MIL "ON" DTC P3190, P3191 and/or P0A0F

Service Category Engine/Hybrid System

Section Engine Control

YEAR(S)	MODEL(S)	ADDITIONAL INFORMATION
2010 – 2011	Prius

Figure 1. Location of Authorized Modifications Label on 2010 and 2011 Prius

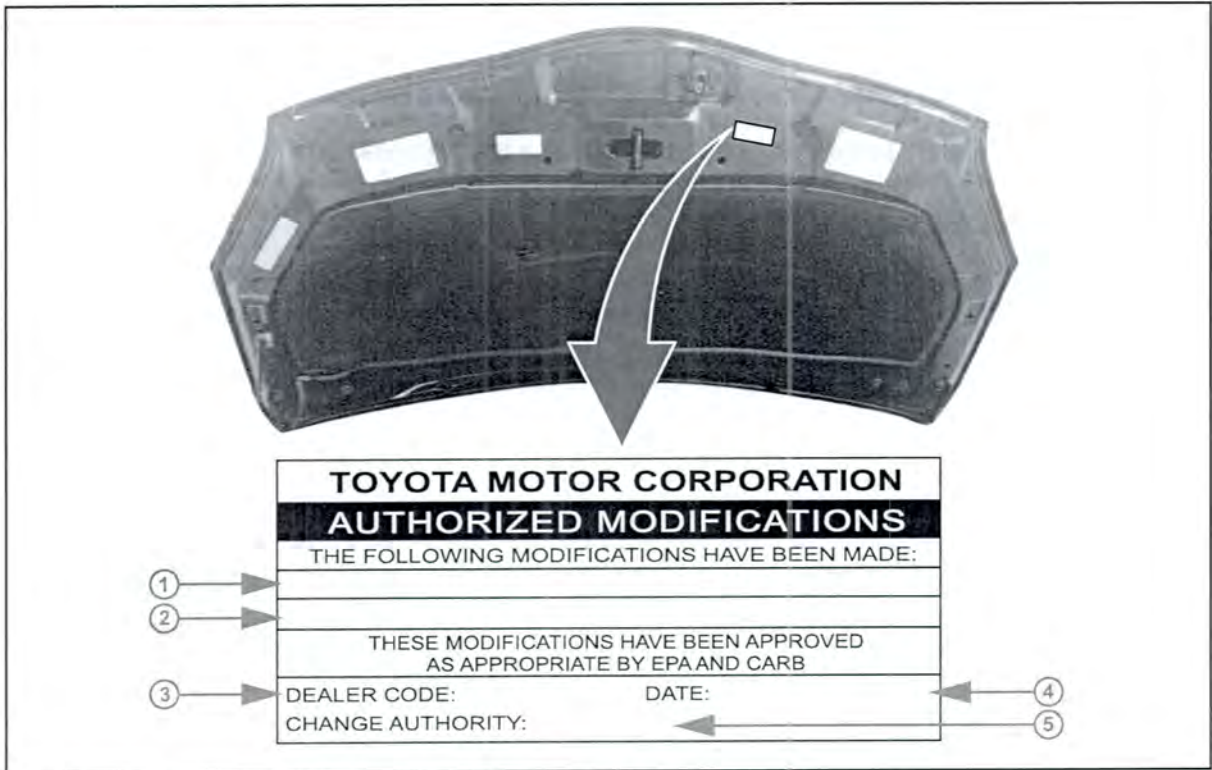
Reinstall and secure any unseated lines, then proceed to step 2.
2. Check for the Authorized Modifications Label affixed to the vehicle in the location shown in Figure 1. Confirm if the ECM (PCM) calibration has been updated. If the calibration ID listed is NOT the latest ECM (PCM) calibration — go to step 3.

4. Install the Authorized Modifications Label.
 - A. Using a permanent marker, enter the following information on the label:
 - ECM part number [*Refer to the **Parts Information** section for the **CURRENT PART NUMBER***]
 - Calibration ID(s) [*Refer to the **Calibration Identification Chart** for the **NEW CALIBRATION ID***]
 - Dealer Code
 - Repair Date
 - Change Authority [***This SB** number*]
 - B. Affix the Authorized Modifications Label to the vehicle at the location shown in Figure 1. The Authorized Modifications Label is available through the MDC, P/N 00451-00001-LBL.
5. Test drive the vehicle to confirm proper vehicle operation.
